Access Compliance Report Public Rights-of-Way (Curb Ramps)

Intersection ID: 14535 Main Street: E_KINGSTON_AV Cross Street: LENNOX_AV Location:

ADA ID: A93562A19070 Ramp Type: Perp Initial Pass/Fail: Fail **Overall Compliance: No** Severity Score: 13.75

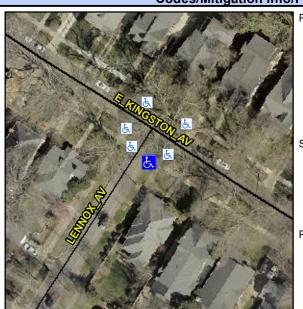
LENNOX AV Street 1 Name Stop Condition-Street 2 StopSign Street 2 Name N/A Stop Condition-Street 1 N/A Possible Solutions: Remove & Replace Entire Ramp. Surveyor Notes: N/A PROW/ADA: Not Found, R304.2.2, R304.5.3

Field Measurements/Component Compliance						
Compliance Description		Data	Comp	liance	Description	Data
N/A	Ramp Length (in)	54.0	No	Ram	Slope (%)	8.4
Yes	Ramp Width (in)	48.0	No	Ram	XSlope (%)	3.3
N/A	Flare Type LT	N/A	N/A	A Flare Type RT		N/A
N/A	Flare Slope LT (%)	N/A	N/A	Flare Slope RT (%)		N/A
N/A	Flare Traversable LT?	N/A	N/A	Flare	Traversable RT?	N/A
N/A	Landing Length (in)	N/A	N/A	DWS	Provided?	N/A
N/A	Landing Width (in)	N/A	N/A	DWS	Contrast?	N/A
N/A	Landing Slope (%)	N/A	N/A	DWS	Length (in)	N/A
N/A	Landing X Slope (%)	N/A	N/A	DWS	Full Width?	N/A
N/A	Landing Curb? (Y/N)	N/A	N/A	DWS	Offset (in)	N/A
N/A	Shared Landing?	N/A				
N/A	Gutter Ponding?	N/A	N/A	Gutte	er Slope (%)	N/A
N/A	Gutter Lip Ht (in)	N/A	N/A	Gutte	er X Slope (%)	N/A
N/A	Painted X Walk1?	No	N/A	Paint	ed X Walk2?	N/A
	X Walk 1 Direction	To NW		X Wa	lk 2 Direction	N/A
N/A	X Walk 1 Width (in)	N/A	N/A	X Wa	ılk 2 Width (in)	N/A
	X Walk 1 Slope (%)	7.3		X Wa	lk 2 Slope (%)	N/A
